# Jackson Hole, Wyoming Environmental Restoration Draft Feasibility Study

**Draft Feasibility Study  
and  
Environmental Assessment  
Comment Response Package,  
Environmental Assessment  
Finding of No Significant Impact,  
Monitoring Plan**

**April 2000**

**Figure 6-1. All Four Areas - Fish Habitat Unit Projections.**

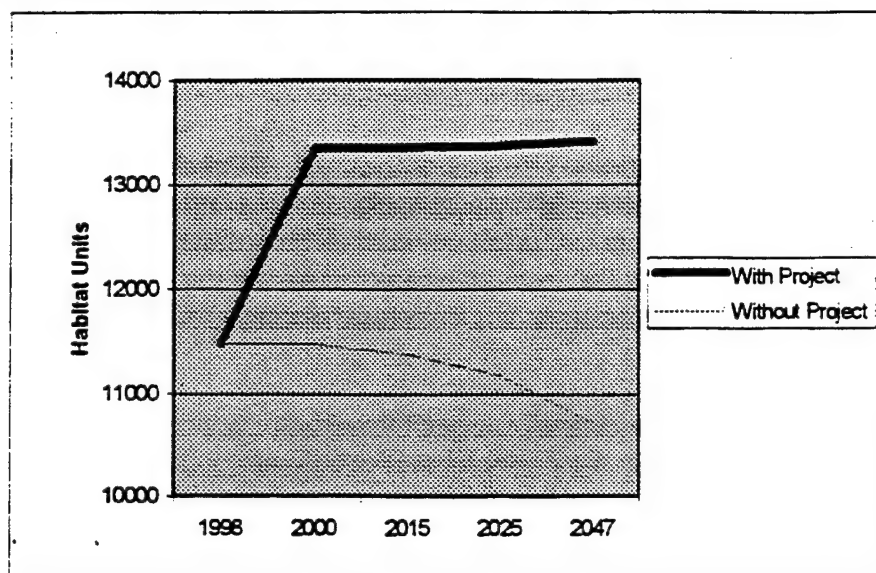
18 6.2.1.1 Cutthroat Trout (Habitat Quantity and Quality Assessment) -- How the assessment of habitat units (with and without project) was determined is unclear. Though the relationships shown in Figure 6-1 may be accurate for a given site, the benefit of this project to the Snake River system as a whole will be negligible and should be noted. Also, unless there is a high level of maintenance on these created habitats, they too will degrade over time.

Comment 18: Figure 6-1 represents a combined estimate of fish habitat unit projections for the four restoration areas and, therefore, is not intended to represent any single site. The Corps recognizes that each site is different and that the quantity and quality of fish habitat that may be restored will vary from site to site. The Corps also recognizes there are numerous areas along the Snake River that could benefit from restoration efforts and that any benefits derived from restoration in the four areas would be a small portion of any overall potential benefits. Monitoring would be used to assess the level of maintenance necessary for the various tools.
